# RENESAS TECHNICAL UPDATE

Product Category	MPU/MCU		Document No.	TN-SY*-A0047A/E	Rev.	1.00
Title	Errata for User's Manual regarding the IIC		Information Category	Technical Notification		
Applicable Product	Renesas Synergy™ S124 MCU Group	Lot No.	Reference Document	S124 Microcontroller Group User's Manual Rev.1.30		
		All

The specified Renesas Synergy S124 User's Manual has incorrect statements about the IIC.

## Page 667 of 1104

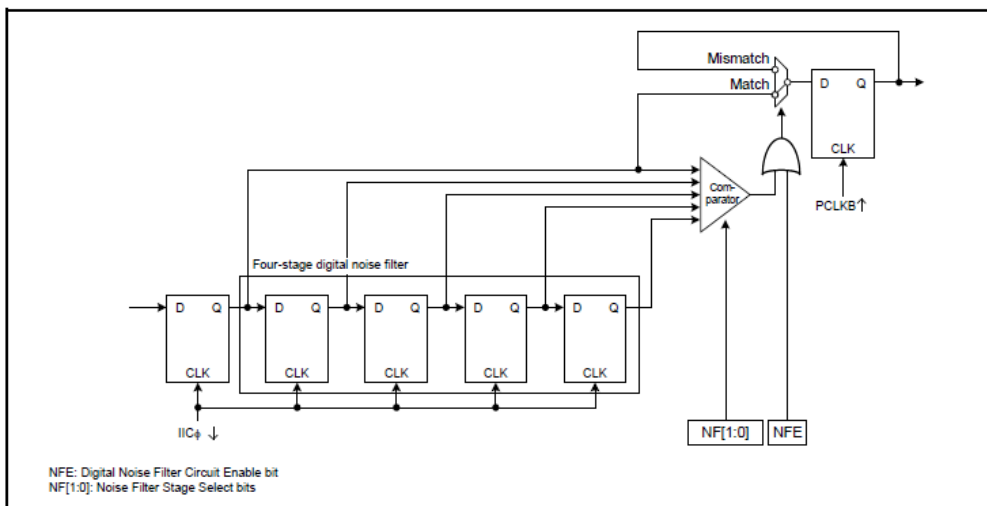
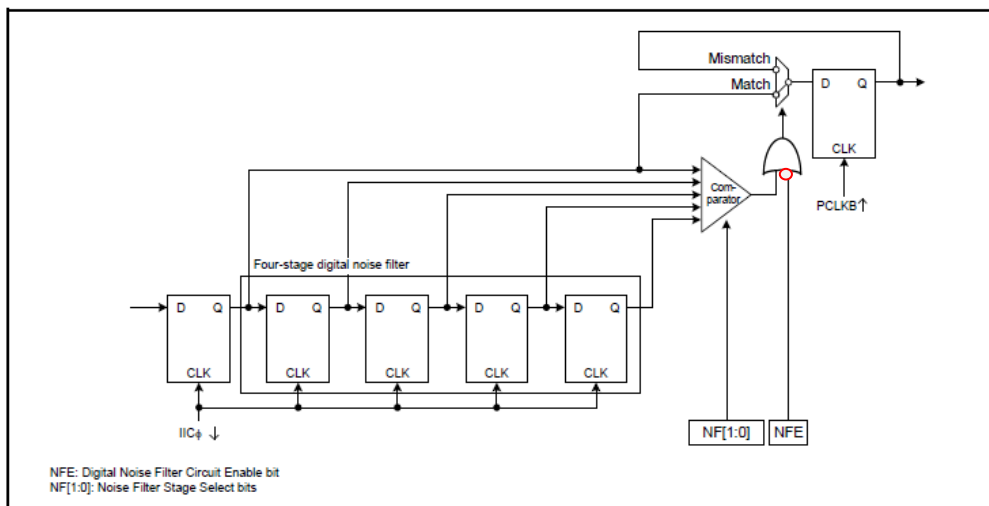
Incorrect Figure

Correct Figure

Incorrect Figure

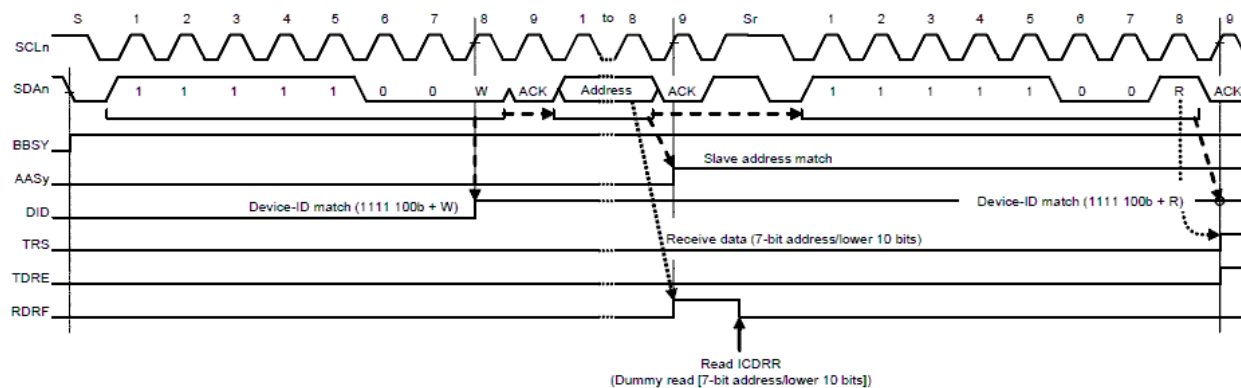
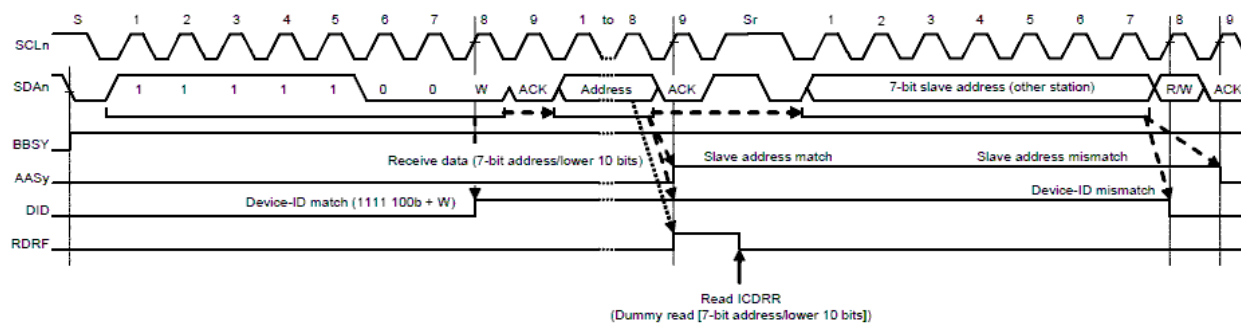
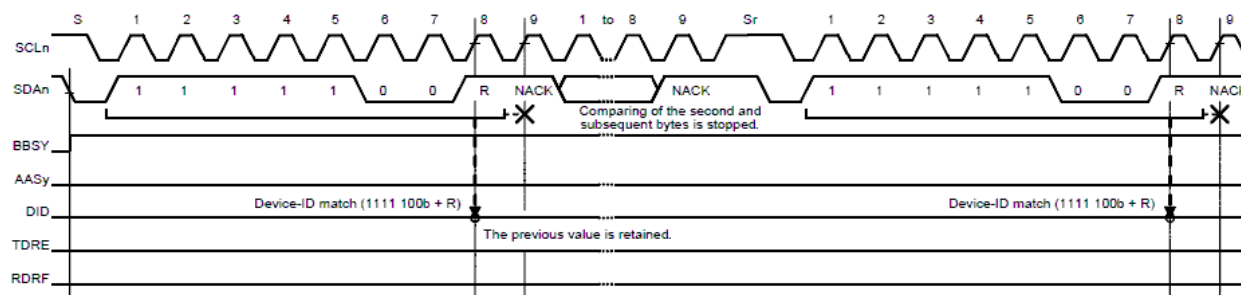
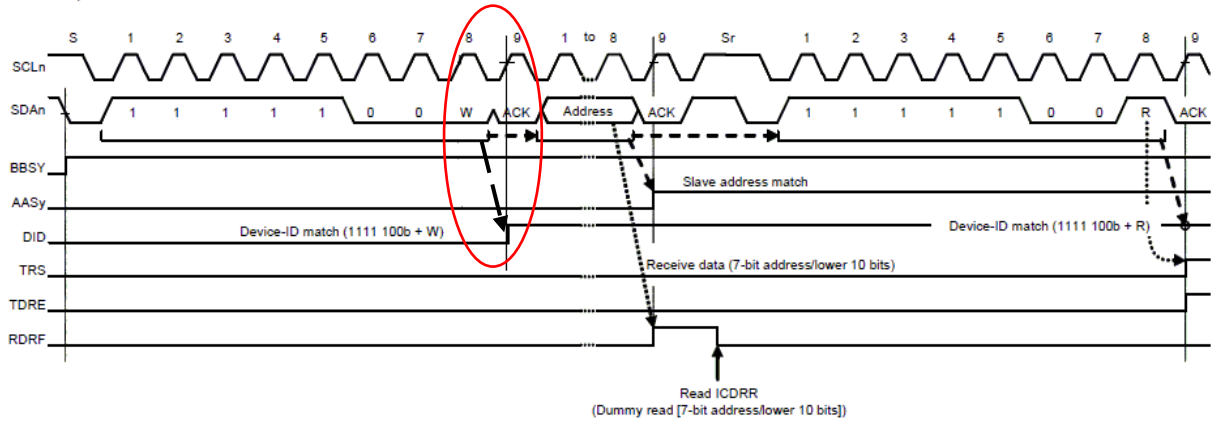
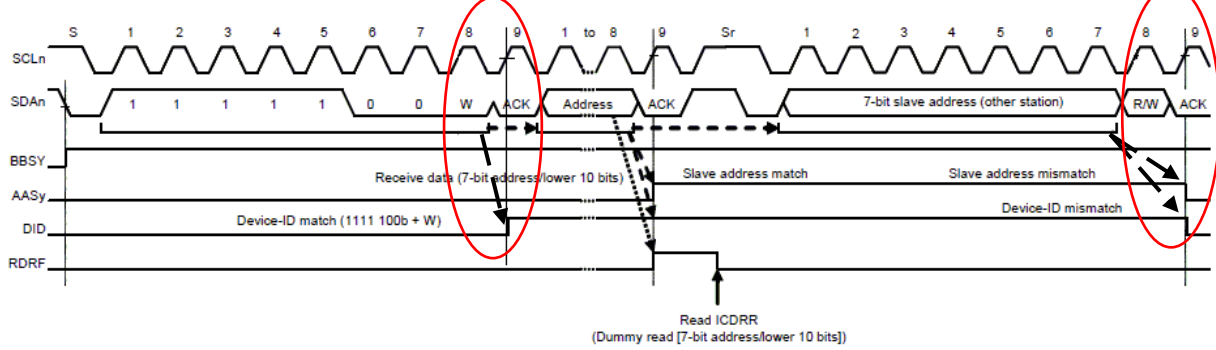
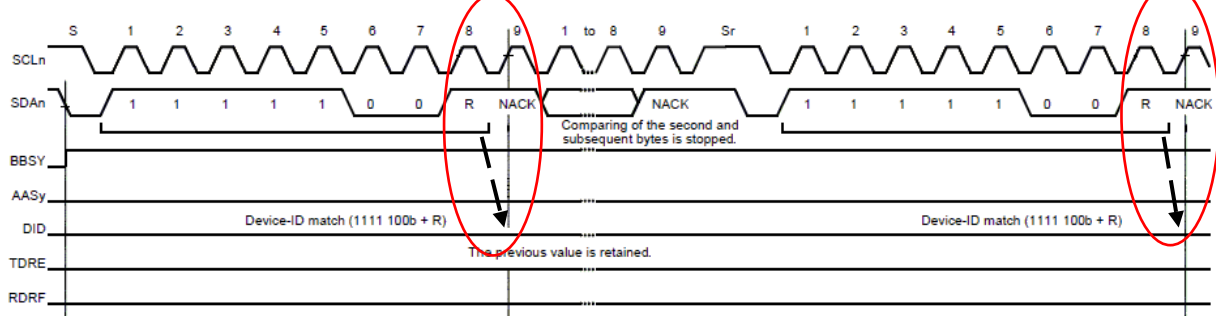
Device-ID reception

When address received after a restart condition is detected does not match the device-ID

When address before the device-ID + R does not match the slave address

Correct Figure

Device-ID reception

When address received after a restart condition is detected does not match the device-ID

When address before the device-ID + R does not match the slave address

Page 708 of 1104

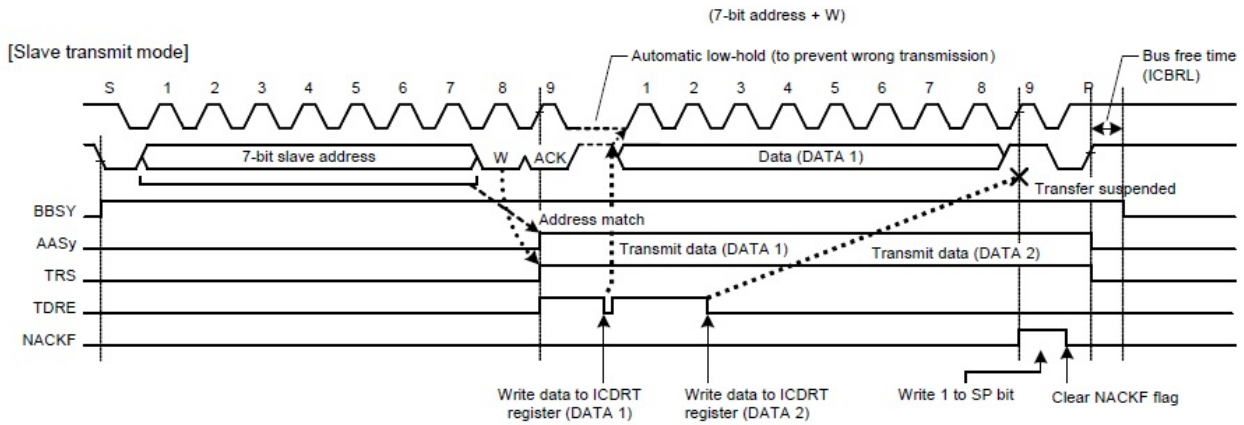
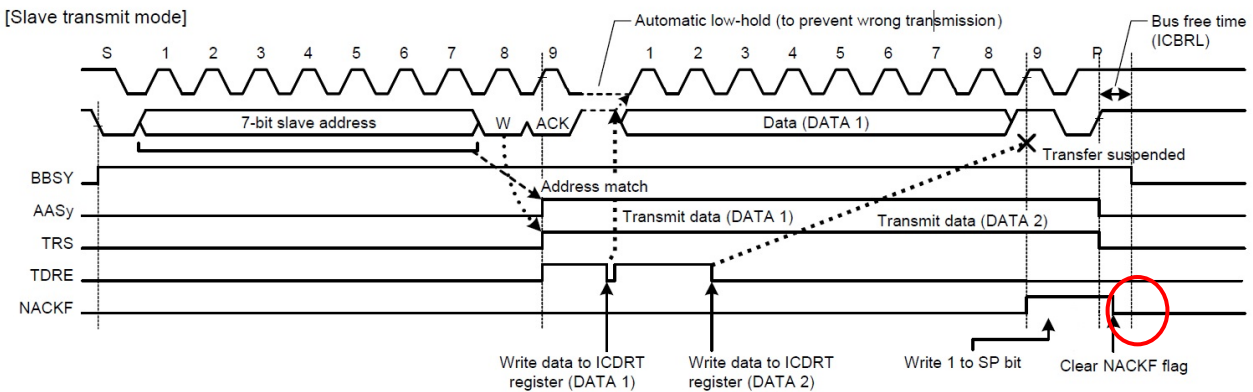
Incorrect Figure

Correct Figure

Page 717 of 1104

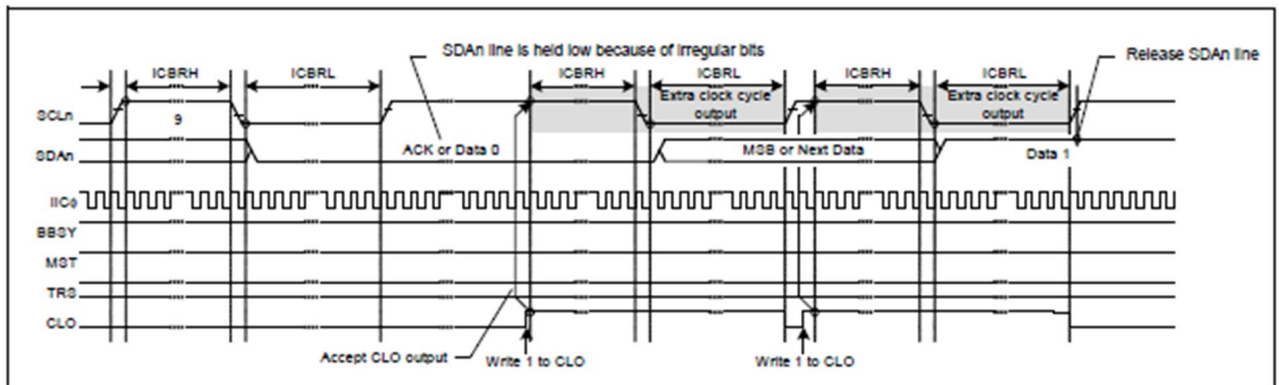
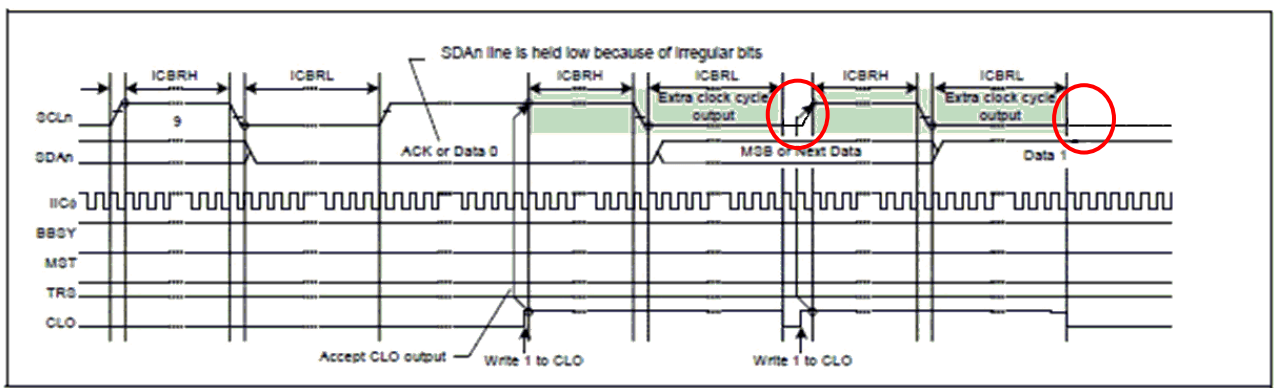
Incorrect Figure

Correct Figure
